Technical *Info*

Retooling the tensioning technology in the Ford 1.8 diesel (CT 983 K1/K2)

Fig. 2
New tension pulley technology

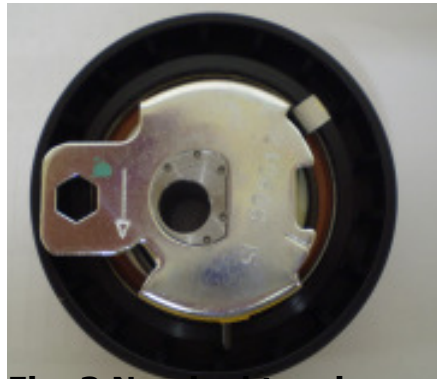
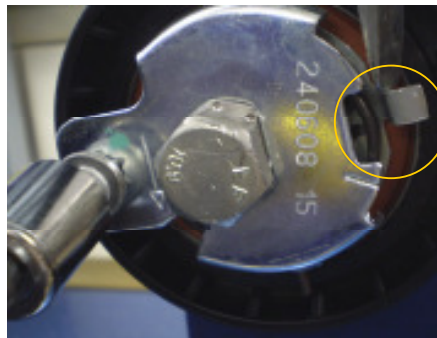
The tensioner pulley in the kit is designed technically differently from how it is installed at the factory.

According to Ford, the new type of tension pulley has to be installed in all 1.8 diesel engines when the timing belt is due to be changed. Given the fact that the structure has been changed completely, clarification is required on how to install or position this correctly.

The new type is a semi-automatic tension pulley which is installed centrally in place of the manual tensioner (50 Nm). Following installation of the timing belt, as normal, the tension is adjusted on the disc on the front by turning it in the imprinted direction of the arrow using an Allen key. Make sure that the recess is opposite the stop lug in approx. 3:00 position. In some older versions, the cover must be filed by a few tenths of a millimeter in the area of the tensioning roller.
